# RENESAS TECHNICAL UPDATE

Product Category	MPU&MCU		Document No.	TN-H8*-A291A/E	Rev.	1.00
Title	H8S/2633 Series and H8S/2643 Series Notes on the SCL rise time in the I <sup>2</sup> C bus interface module		Information Category	Technical Notification		
Applicable Product	H8S/2633W Series	Lot No.	Reference Document	Following hardware manuals: H8S/2633 Series Rev. 5.00 H8S/2643 Series Rev. 3.00		
	H8S/2643W Series	All lots

Figure 1 Bit Synchronization Circuit Timing

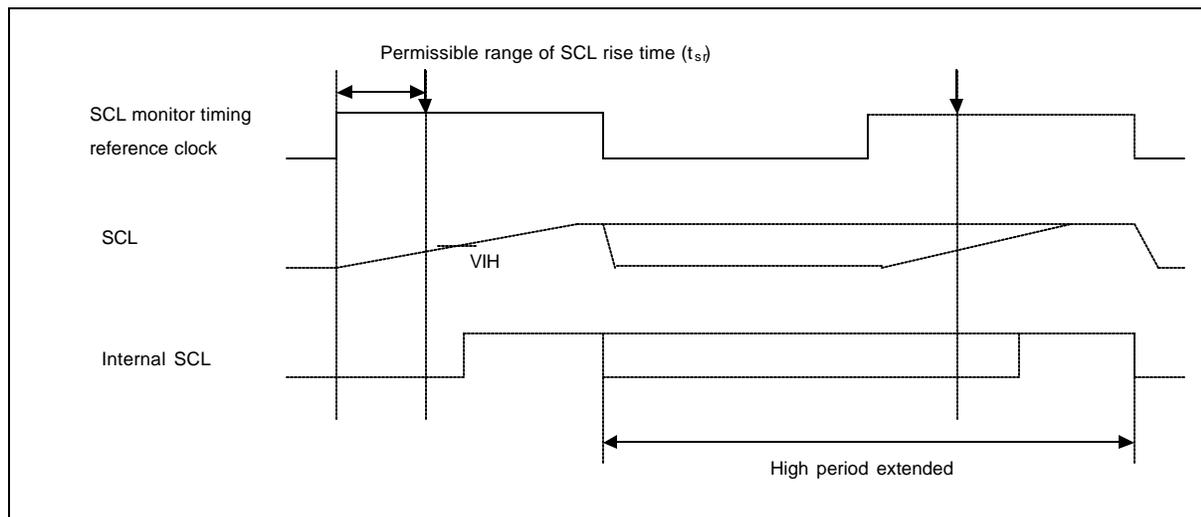
Therefore, SCL is monitored and synchronized for each bit during communication. Figure 1 shows the bit synchronization circuit timing, and table 1 lists the permissible range of the SCL rise time ( $t_{sr}$ ). If SCL does not rise within the permissible range ( $7.5 t_{cyc}$  or  $17.5 t_{cyc}$ ) of the SCL rise time ( $t_{sr}$ ), the internal SCL high period is extended to the next rate.
